OFFICE OF
FRESNO
IRRIGATION DISTRICT

RE: Review of 30% High Speed Rail Plans for Segment 1A

(Veteran's Boulevard to Stanislaus Street)

FID Facilities: Herndon Canal No. 39 Lisenby No. 45, Victoria No. 42, Victoria Colony No. 43, Tracy No. 44, Cole West Branch No. 40, Cole South Branch No. 40, and Dry Creek No. 75.

CONTRACT NO.
DRAWING NO. UT-C4020
SCALE AS SHOWN
SHEET NO.

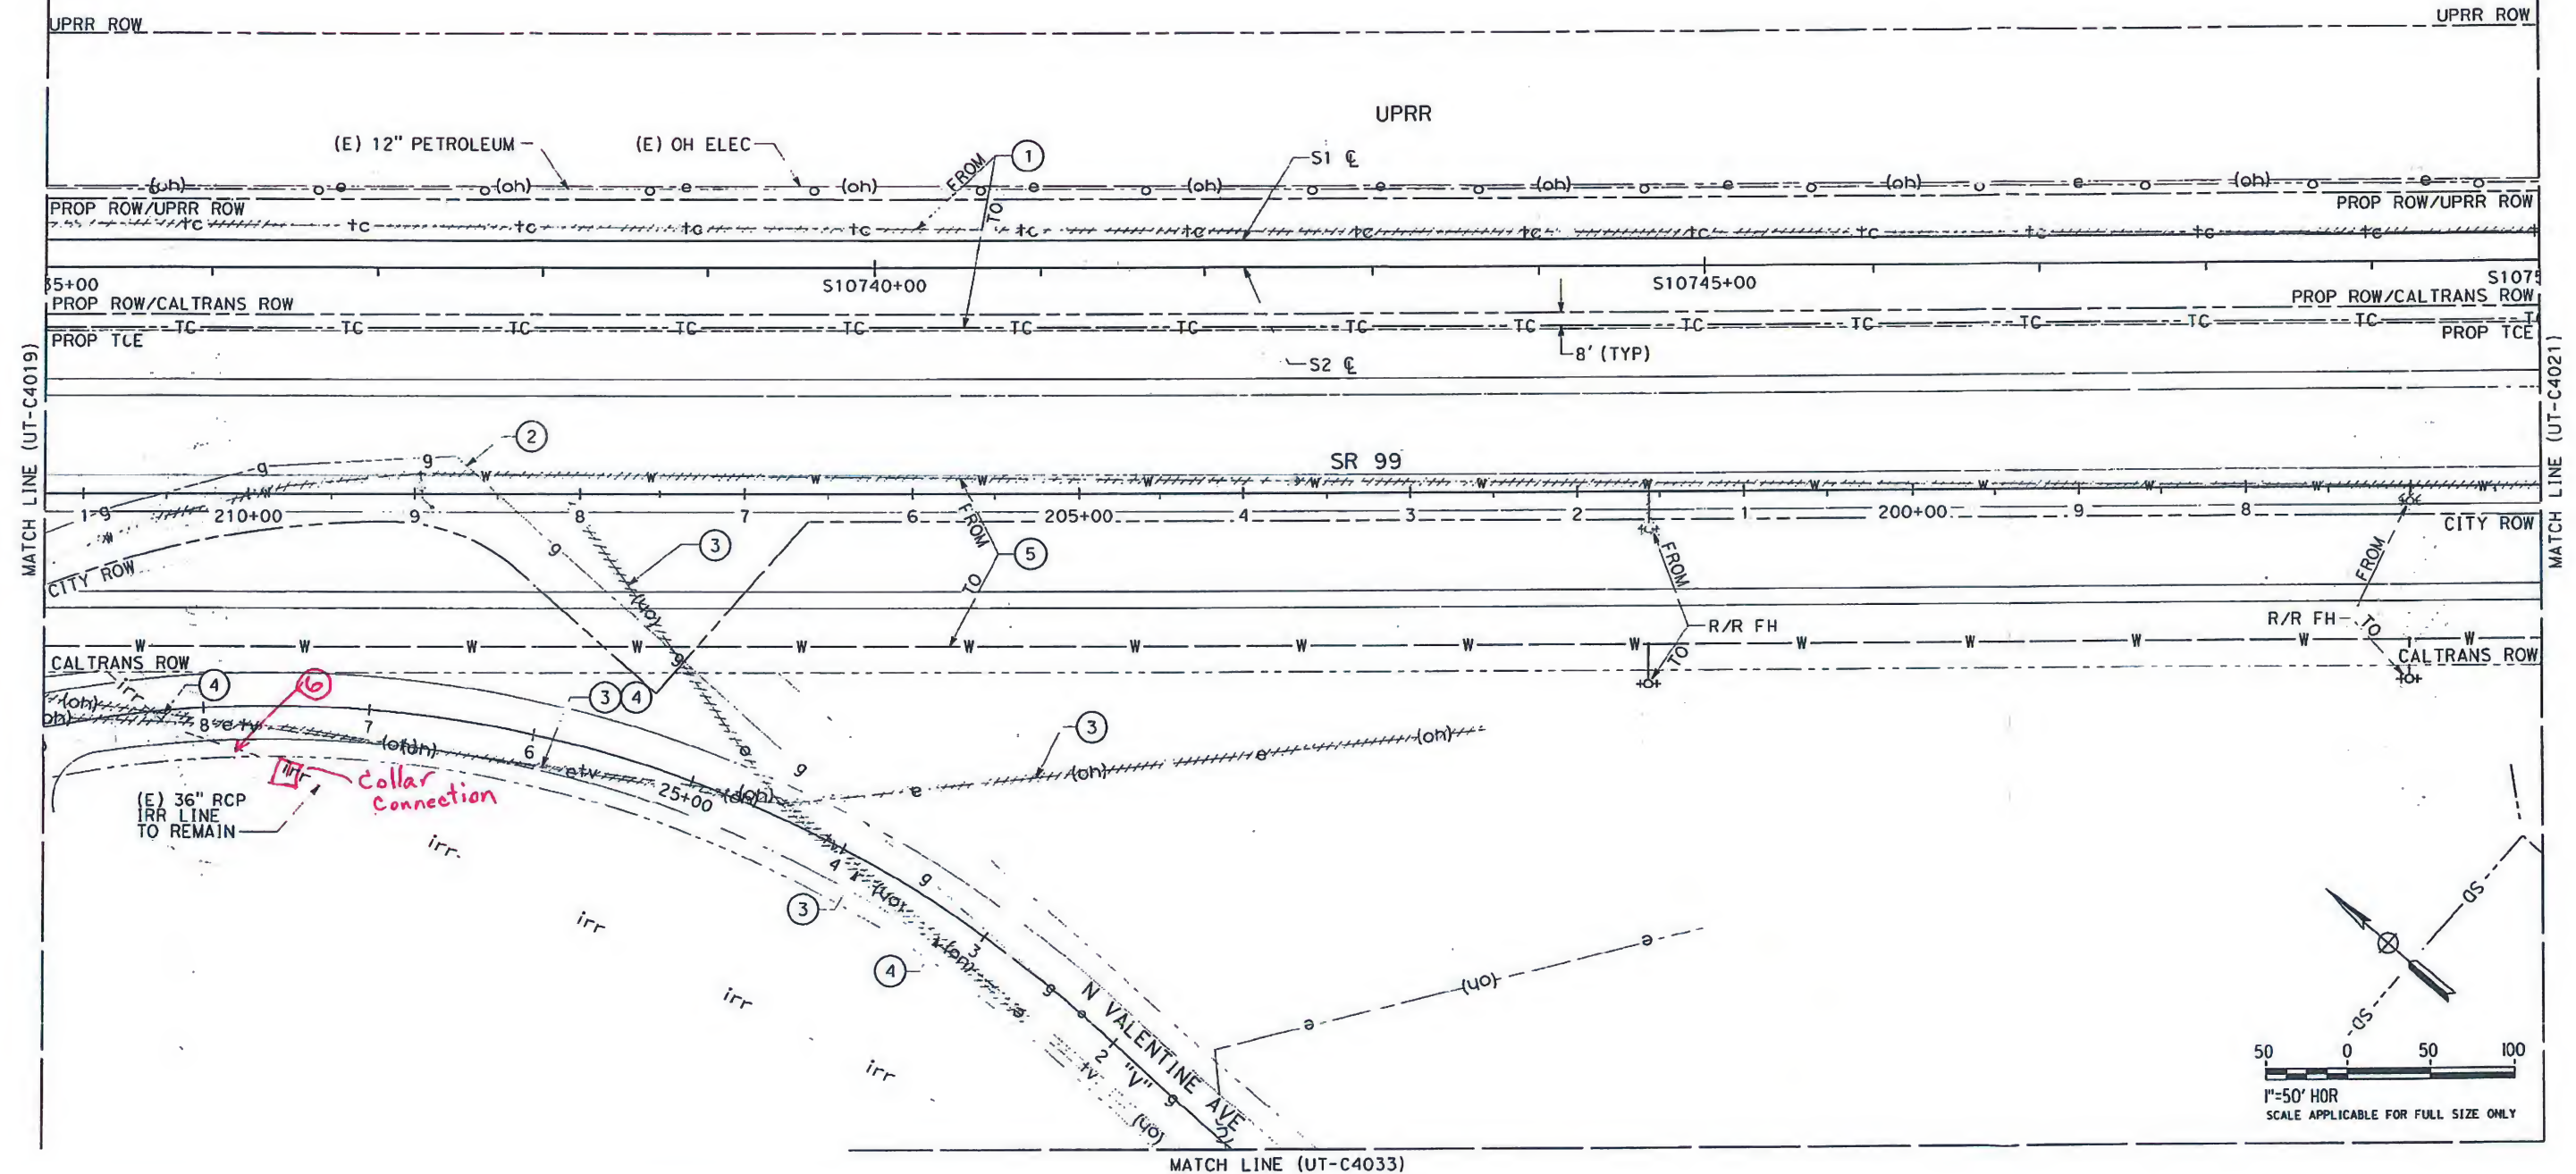
Victoria No. 42, Victoria Colony No. 43, and Tracy No. 44 (HSR, Hwy. 99, Valentine and Dakota avenues)

- Provide a plan/profile along the centerline of FID's facility that shows the limits of the pipeline construction and connection to existing pipeline, and includes location of other utility crossings in plan and profile views.

- New pipeline will be required in all locations that will be within proposed CHSRA, Caltrans or City right of way due to the age of the facilities, non-reinforced pipe and inadequate structural properties to handle additional loading or vibration from the movement of heavy equipment and vehicles during construction. The alignment of these facilities needs to be reconsidered to eliminate angle points under roadways and to allow for any standpipes or box structures to extend above ground.

- The existing box structure on the west side of Highway 99 shall be replaced in accordance with FID standards. A possible relocation is located on a markup provided. A detail for this structure shall be included in the plans. The location of this structure shall be confirmed to be accessible to FID at all times. In addition, this box is a diversion box and headgate structure for both the Victoria Colony No. 43 and the Tracy No. 44 and will therefore require two gates at this location.

- Plans shall include or reference the FID standard concrete collar connection detail where new ASTM C-361 Rubber-Gasketed Reinforced Concrete Pipe (RGRCP) will connect to existing concrete pipe at both the east and west limits of the facility relocation.

- The casing shall extend across the CHSRA's full right of way width. More detail is needed to understand the location of construction/receiving pits and the extent of construction to determine the work within the UPRR right of way. The box structure on the upstream side (within the UPRR right of way) will likely need to be replaced with a 60-inch standpipe or similar structure.

- Add the name of FID's facility to all appropriate plan sheets, including the Utility Information tables on the Utilities sheets.
- Plan sheets reviewed include CV-R1009-R99, CV-G1010-R99, CV-G1009-R99, CV-G1017-R99, CV-G1007, CV-R1017-R99, UT-C4019, UT-C4020, C4033. Please identify any other sheets that cover the area of this FID facility.
